## SUBJECT: 826-1546 Melt-cycle replacement timer

To replace the mechanical melt-cycle timer on Frymaster MJ45, MJ47 and MJCF series fryers:

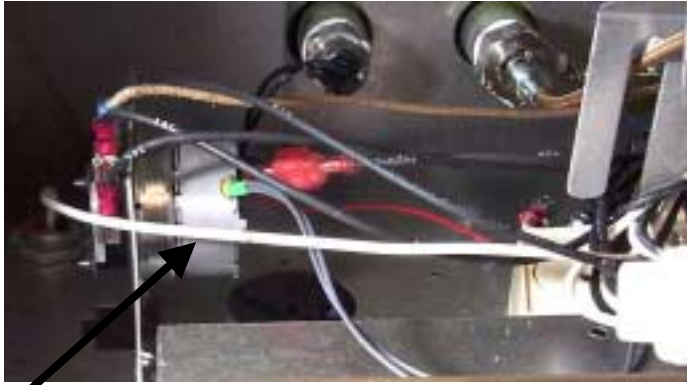
The enclosed circuit board is attached to a metal plate. The unit is a direct replacement for the mechanical melt-cycle timer:

Removing the control panel reveals the mechanical timer. The metal plate that holds the unit in place is secured with two screws. Remove the screws, lift out the timer and detach the wires.

The solid state timer mounted on a metal plate, bolts into the space previously occupied by the mechanical timer.

1. Remove Power from unit.
2. Access timer by removing the control panel.
3. Remove timer by removing two screws that hold it in place. Detach wires.
4. Attach wires as directed in table below to the new timer.
5. Bolt new timer into place. Reattach control panel.

Position on new board	MJ45/CF AG and newer	MJ45 Prior to AG	MJ47 All units
Ground	To position 12 of 20-pin block	To position 16 of 20-pin block	To number 4 of clip terminals
24VAC	To wire 14C	To wire 15C	To wire 28C
Melt	To wire 13C	To wire 13C	To wire 29C
Valve	To thermostat	To wire 16C	To thermostat
